**HISTORIC PRESERVATION REVIEW BOARD
STAFF REPORT AND RECOMMENDATION**

Landmark/District: **Georgetown Historic District** (x) Agenda
Address: **3321 and 3323 Q Street NW**
Meeting Date: **March 23, 2023** (x) Subdivision
Case Number: **23-162** (x) Alteration
(x) Concept

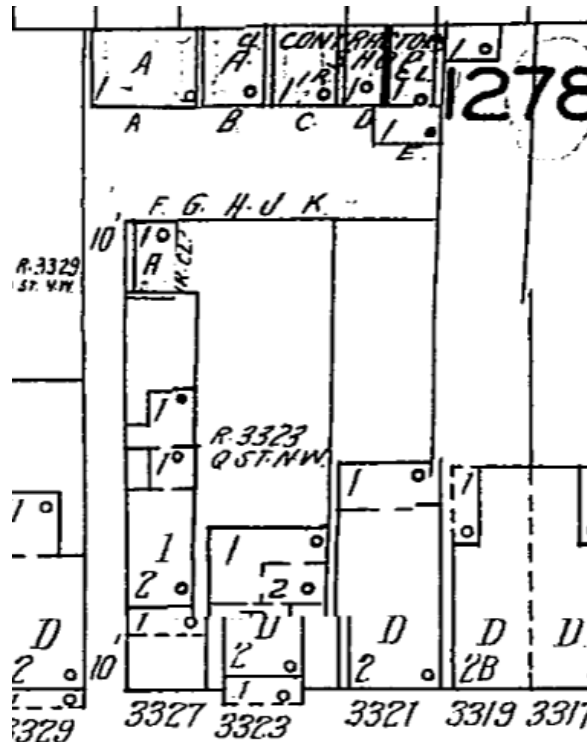
As the above map indicates, the rearmost portion of the yard was once truncated by the alley. While it is far from ideal to alienate a historic part of the property, the proposal does leave a significant amount of rear yard, because the house itself is shallow (and it would foreclose opportunities to add to that house).
